Access Compliance Report

Public Rights-of-Way

(Curb Ramps)

Intersection ID: 20081	Main Street: EMERYWOOD_DR	Cross Street: FARMBROOK_DR	Location: E
ADA ID: 317FDA059229	Ramp Type: Perp	Initial Pass/Fail: Fail	Overall Compliance: No
		Severity Score: 37.5

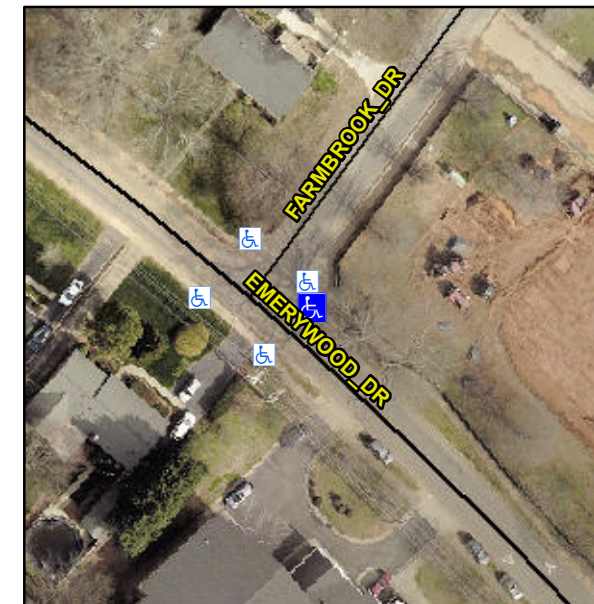
Not Found, R304.2.2, R304.5.3

Compliance	Description	Data	Compliance	Description	Data
N/A	Ramp Length (in)	62.0	No	Ramp Slope (%)	11.1
Yes	Ramp Width (in)	66.0	No	Ramp XSlope (%)	8.9
N/A	Flare Type LT	N/A	N/A	Flare Type RT	N/A
N/A	Flare Slope LT (%)	N/A	N/A	Flare Slope RT (%)	N/A
N/A	Flare Traversable LT?	N/A	N/A	Flare Traversable RT?	N/A
N/A	Landing Length (in)	N/A	N/A	DWS Provided?	N/A
N/A	Landing Width (in)	N/A	N/A	DWS Contrast?	N/A
N/A	Landing Slope (%)	N/A	N/A	DWS Length (in)	N/A
N/A	Landing X Slope (%)	N/A	N/A	DWS Full Width?	N/A
N/A	Landing Curb? (Y/N)	N/A	N/A	DWS Offset (in)	N/A
N/A	Shared Landing?	N/A			
N/A	Gutter Ponding?	N/A	N/A	Gutter Slope (%)	N/A
N/A	Gutter Lip Ht (in)	N/A	N/A	Gutter X Slope (%)	N/A
N/A	Painted X Walk1?	No	N/A	Painted X Walk2?	N/A
	X Walk 1 Direction	To SW		X Walk 2 Direction	N/A
N/A	X Walk 1 Width (in)	N/A	N/A	X Walk 2 Width (in)	N/A
	X Walk 1 Slope (%)	6.0		X Walk 2 Slope (%)	N/A
	X Walk 1 X Slope (%)	0.1		X Walk 2 X Slope (%)	N/A

Remove & Replace Entire Ramp.
